STAFF REPORT
COMMUNITY DEVELOPMENT DEPARTMENT

SUBJECT: H-2020-0100
Compass Pointe Subdivision

LOCATION: The site is located at 3247 S. Locust Grove Road, in the NE ¼ of the NE ¼ of Section 30, Township 3N., Range 1E.

D. Open Space Exhibit (dated: ~~11/02/2020~~~~1/21/2021~~ 2/18/2021) **NOT APPROVED**

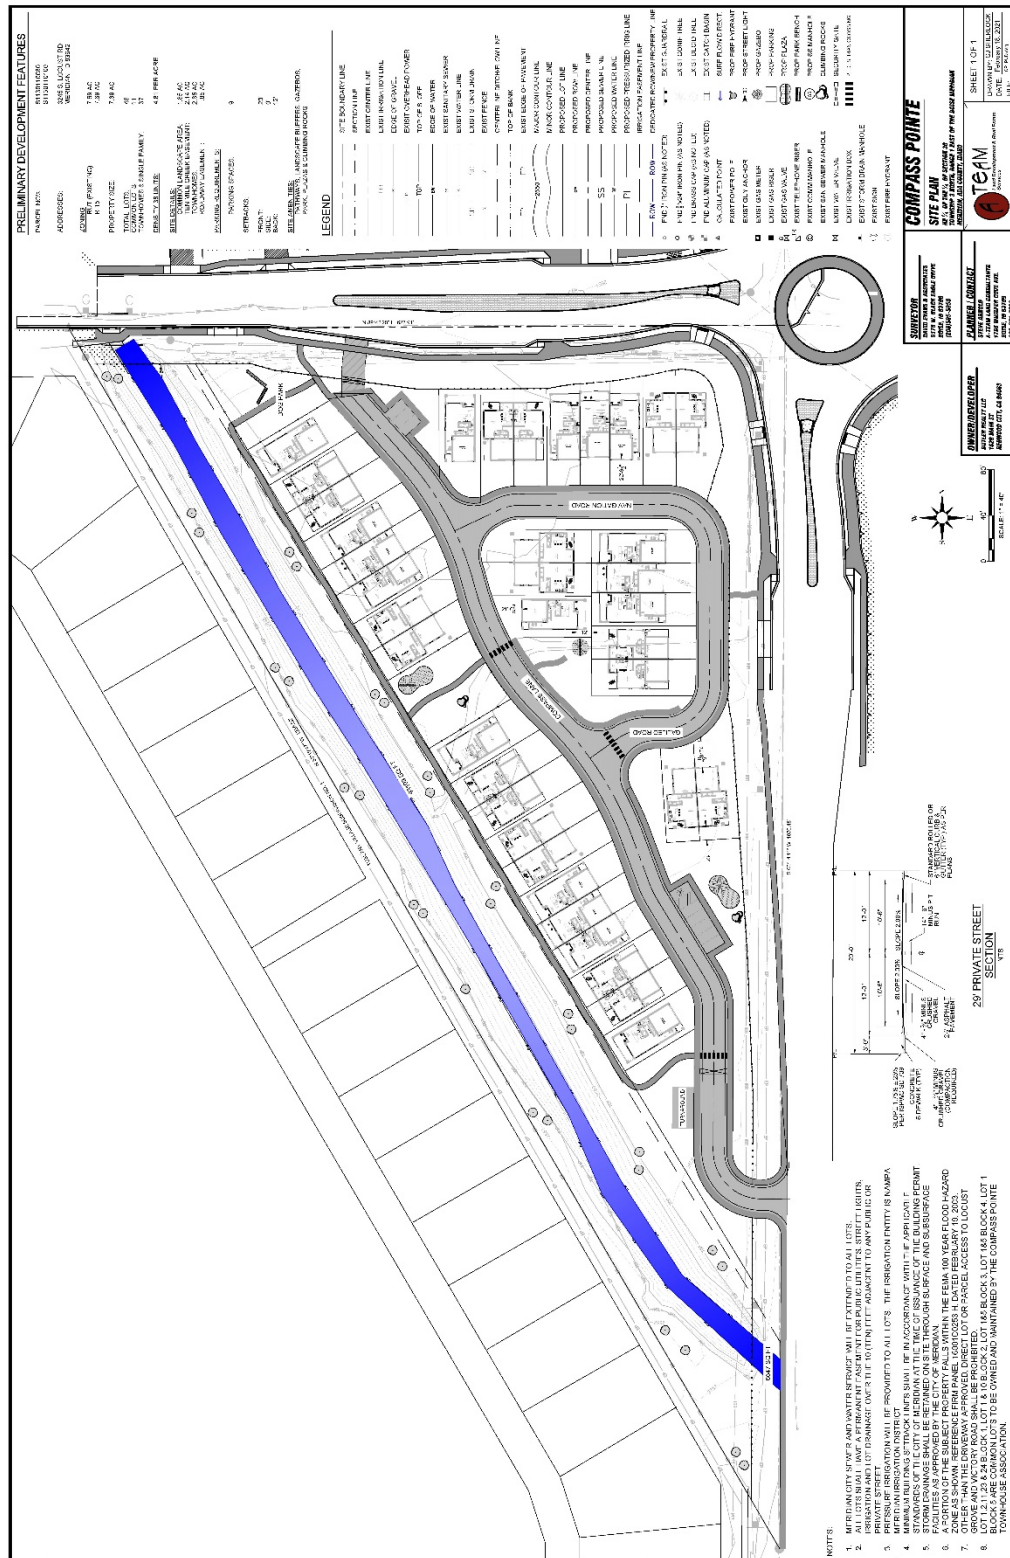
A minimum of 10% **qualified** open space meeting the standards listed in UDC 11-3G-3B is required. According to the property size of 7.69 acres, the Applicant should supply at least 0.77 acres of qualified open space, or approximately 33,500 square feet. The applicant is proposing ~~3.2891~~ 3.4 acres of open space, of which ~~2.84~~ 3.4 acres is shown as qualifying open space on the ~~submitted~~ revised open space exhibit (see Section VIII.D).

Some of the area listed as qualifying open space by the Applicant does not meet UDC standards due to their size not being at least 5,000 square feet or being near the 50' x 100' dimensions. Once this area is removed, the qualified open space proposed is ~~2.6897~~ 2.84 acres, down from 2.84; the Applicant should revise the open space exhibit to correctly label the qualified open space by removing Lot 23, Block 1, Lot 1, Block 2, Lot 4, Block 3, and Lot 3 Block 4. More importantly, the
